**KOLIN Philippines International Inc.
Survey Form**

Customer Name: XNKEOTO FLUMAX Date: 1-18-26
Address: PHASE 1 GC KATIPUNAN EXT. VICTA HEAL CUISINA SJR No.: 24/27
SPRD. 130M BETWEEN HILLS. UNDER CITY

Please be informed that the air-conditioner you intend to purchase is under capacity as compared to the following unit that we proposed:

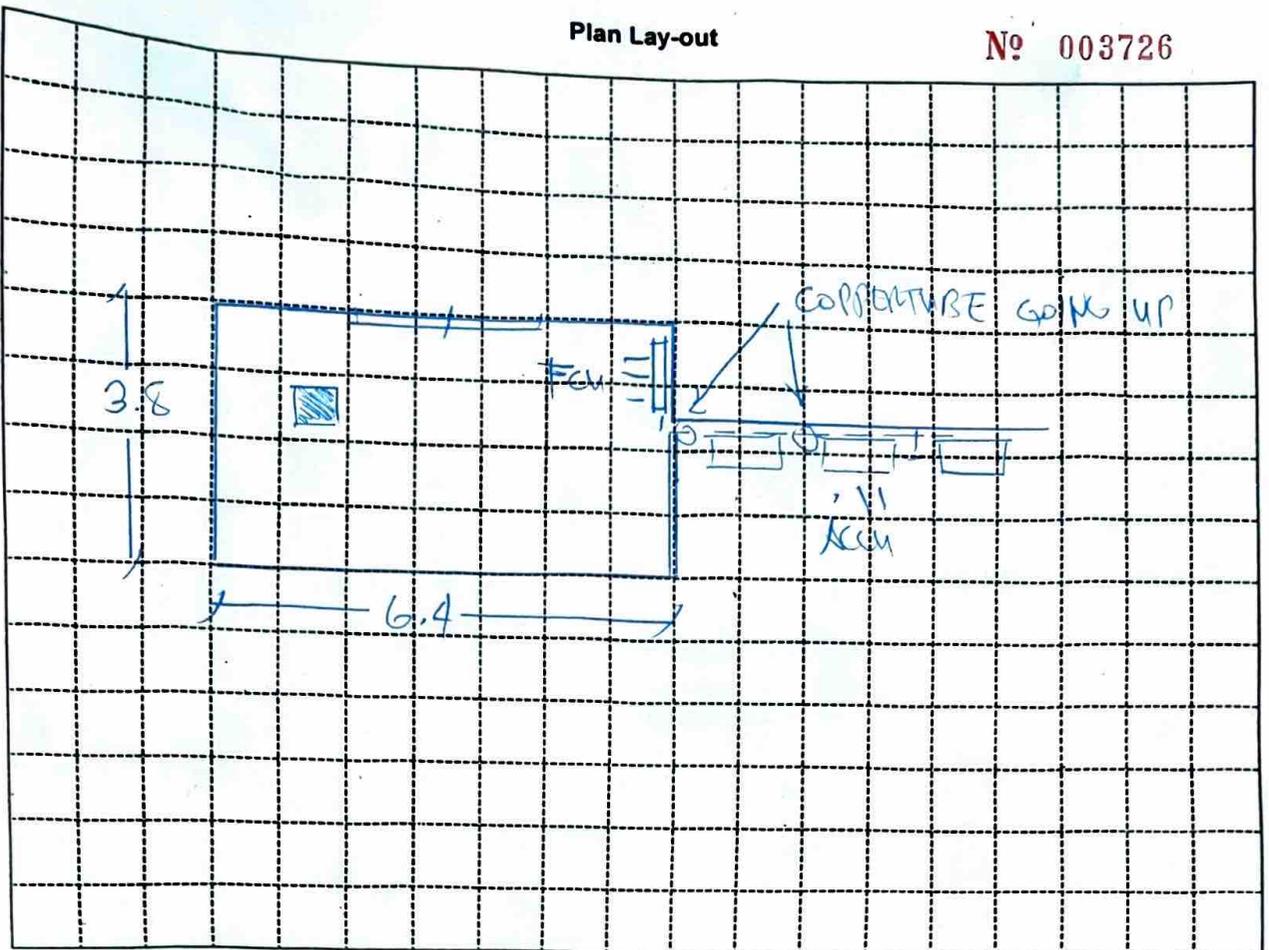
- Plastering, carpentry and restoration works are to be done by the customer.
- Wiring of electrical supply from main panel to air-conditioning unit are to be done by the customer.
- Processing of mechanical plan, working permit, electrical permit are to be done by the customer.
- Other concern: CUSTOMER NEED TO PROVIDE POWER SUPPLY AT THE OUTDOOR UNITS. EXPOSE COPPER TUBE AND ROYAL COND INTO WALLS. NEED PLUMBING AS THROUGH BRACKET, NEED SCREWS. ON SITE FABRICATED WITH LEDGE BRACKET. NEED WATER DUE TO UNDERCUTTING

Indoor Unit Location : RIGHT CORNER OF WALL, UP AXES
 Outdoor Unit Location : UP OF AXES IN BETWEEN CR WINDOW, LEVEL OF TOP OF UNIT AND TOP OF WINDOW.
 Pipe Length : 20 FT / 6 METERS.
 Special Note :
